Access Compliance Report

Public Rights-of-Way

(Curb Ramps)

| Intersection ID: 52311 | Main Street: IMPATIEN_DR | Cross Street: LUPINE_CT | Location: SW |

| ADA ID: 0D76D4F866A0 | Ramp Type: BlendTrans1 | Initial Pass/Fail: Fail | Overall Compliance: No |

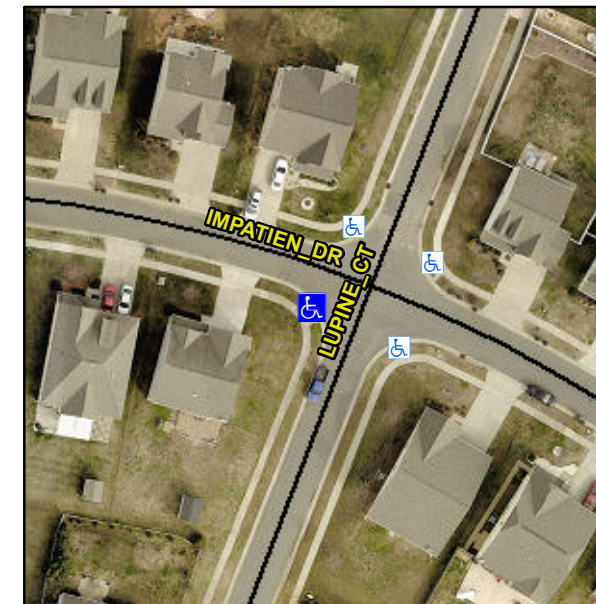
Not Found, R304.5.1

| Compliance | Description | Data | Compliance | Description | Data |
|------------|-----------------------|------|------------|-----------------------------|------|
| No | Ramp Width (in) | 47.0 | Yes | BlendTrans XSlope (%) | 0.2 |
| | | | No | Curb Slope (%) | 11.9 |

Remove & Replace Curb Ramp With Two New Directional Ramps or Equivalent.
